SERVICE NEWS > 21 GEARBOX > 21.03.06 GEAR ENGAGEMENT/SELECTION CABLES  
SEIZING, HARDENING - SERVICE SOLUTION[Go back to User's Manual](#)

Fiat Panda (169)

2125 1 261 L F      **GEAR ENGAGEMENT/SELECTION CABLES**  
Seizing, hardening - Service Solution21  
03.06

**C)** Replace the gear engagement/selection cables (1 - Fig. 1) with new ones from the Parts Dept. completing the operations already partly carried out in points A and B (refer to the Service Manual - Op 2125C30).**Fig. 1**

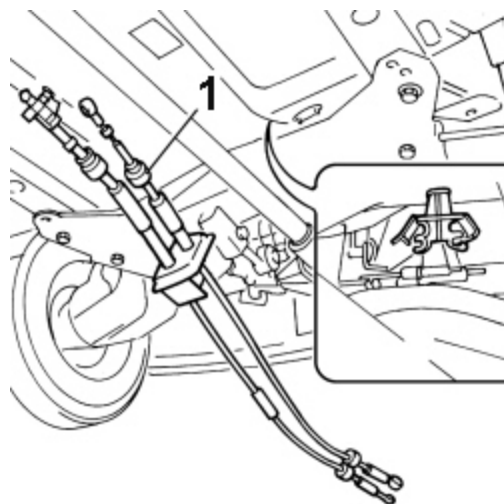
Seizing of the gear engagement cable due to the deterioration of the (PTF) tube inside the outer casing that guides the steel cable.

Only for vehicles in the batch of **chassis from 175913 to 554770**, check that the problem reported is due to the gear engagement/selection cables and, if necessary, replace them following the Operating Cycle below.
